April 29, 2016

**SUBJECT: CATAWBA NUCLEAR STATION, UNITS 1 AND 2 - ISSUANCE OF
AMENDMENTS REGARDING MEASUREMENT UNCERTAINTY RECAPTURE
POWER UPRATE (CAC NOS. MF4526 AND MF4527)**

Amendment No. 281
Renewed License No. NPF-35

Figure 3.4.3-1
(UNIT 1 ONLY)
RCS Heatup Limitations

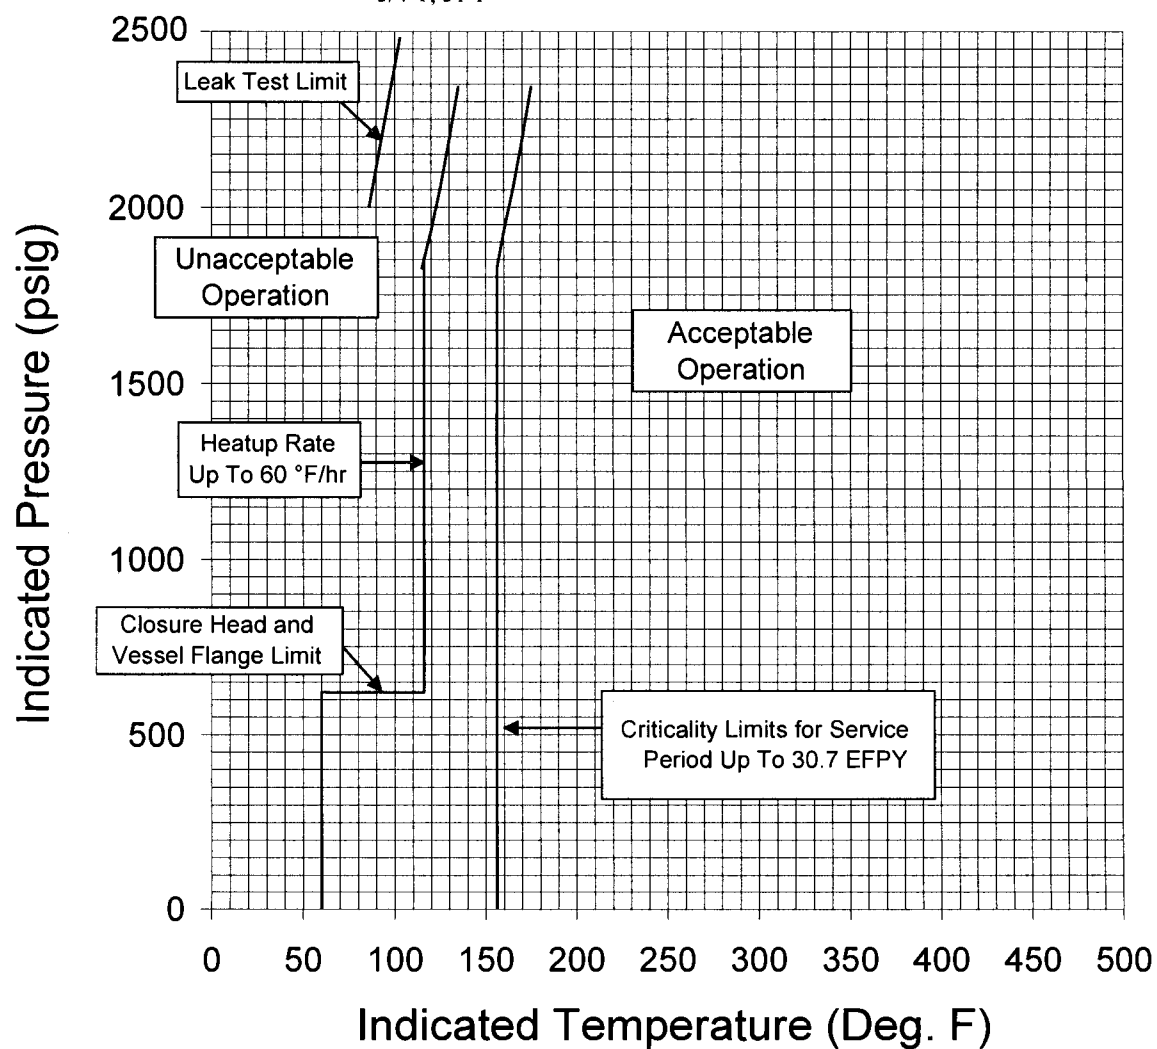
Limiting ART at 30.7 EFPY: 1/4-T, 42°F

3/4-T, 31°F

TS Figure 3.4.3-1, RCS Heatup Limitations, and Figure 3.4.3-2, RCS Cooldown Limitations

Figure 3.4.3-2
(UNIT 1 ONLY)
RCS Cooldown Limitations

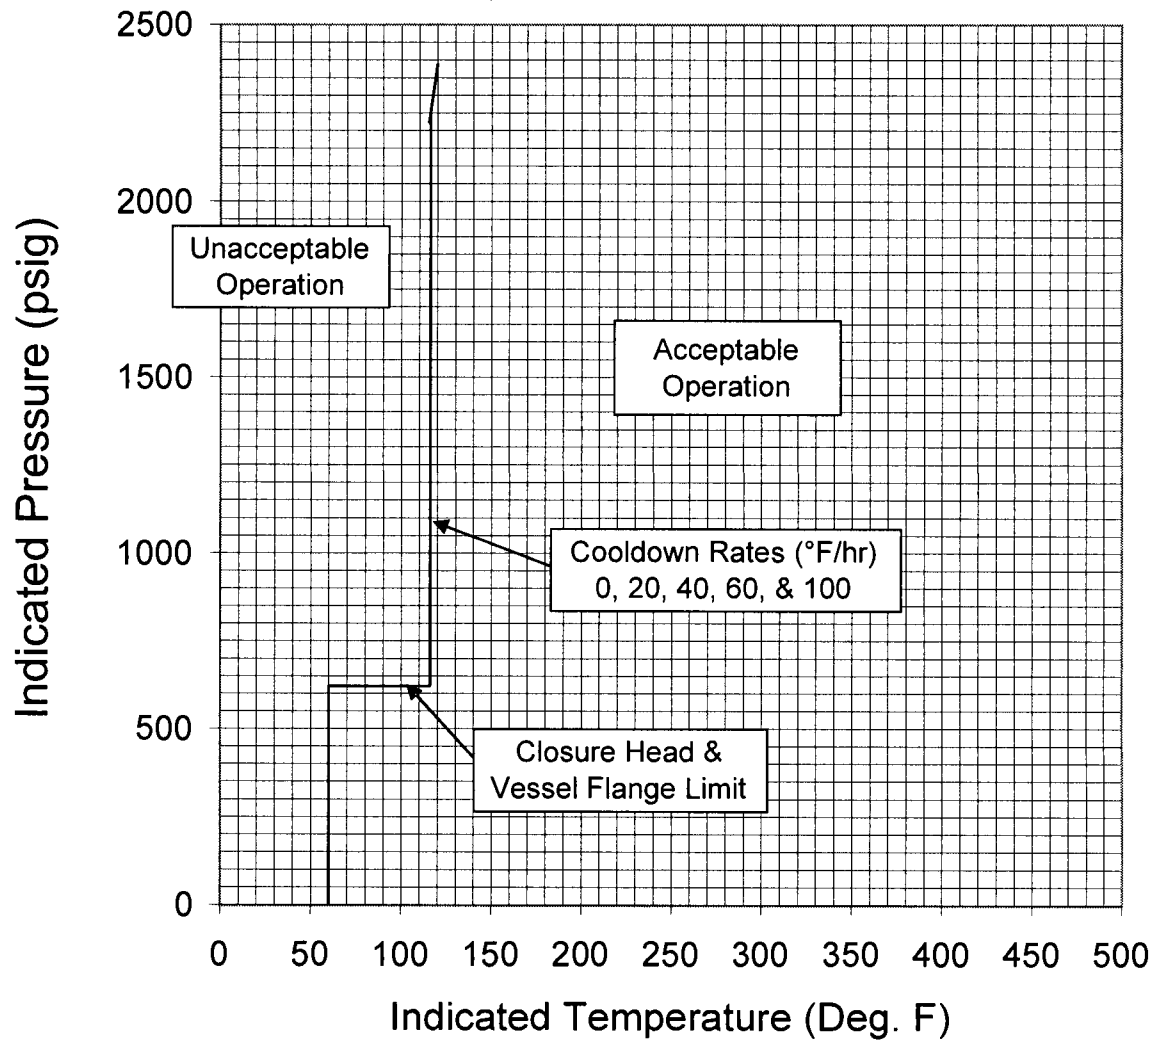
Limiting ART at 30.7 EFPY: 1/4-T, 42°F

3/4-T, 31°F
